CITY OF FORT LAUDERDALE

CASE COMMENT REPORT

CASE NO. UDP-S24062

CASE:	UDP-S24062
MEETING DATE:	October 22, 2024
REQUEST:	Site Plan Level II Review: 8-Unit Townhouse Development
APPLICANT:	Duke at 837 NE 20th Avenue, LLC.
AGENT:	Gustavo Carbonell, Architect
PROJECT NAME:	Townhouse for Crown Holdings, LLC.
PROPERTY ADDRESS:	838 NE 20th Avenue
ZONING DISTRICT:	Residential Office (RO)
LAND USE:	Medium-High Residential
COMMISSION DISTRICT:	2 – Steven Glassman
NEIGHBORHOOD ASSOCIATION:	Victoria Park Civic Association
CASE PLANNER:	Michael Ferrera

Articulation and Material

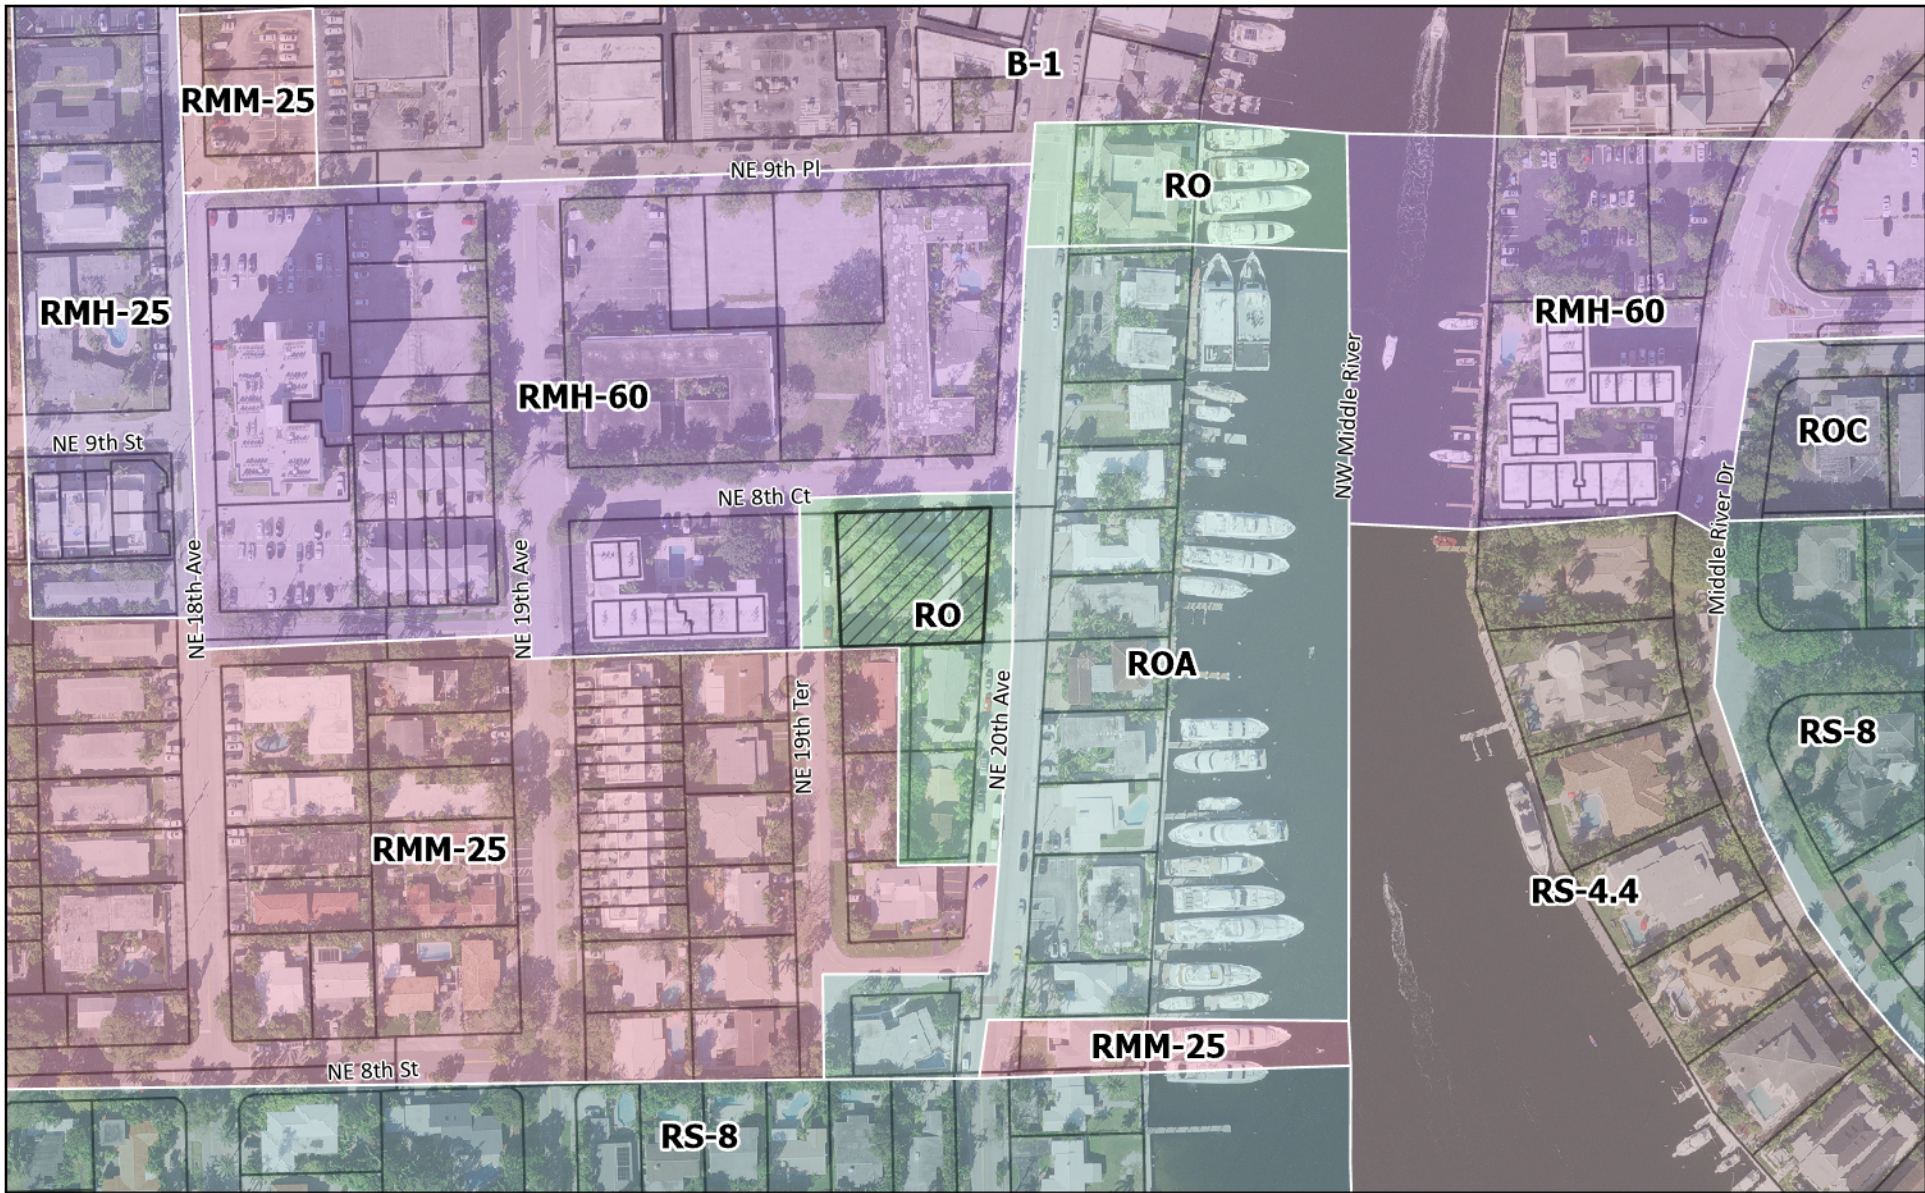
21. As proposed, there is insufficient information to thoroughly comment on the overall design of the buildings. However, based on the elevations provided, the townhouse building appears too linear. More diversification in design needs to be incorporated such as building articulation with varying step backs, material changes, minor wall offsets, height variations, and accent lines. See below for examples. These images are meant to provide a visual representation of certain design aspects mentioned above and are not all encompassing of potential solutions. In addition, staff will review and provide additional commentary upon the next resubmittal when colored elevations and renderings are provided.
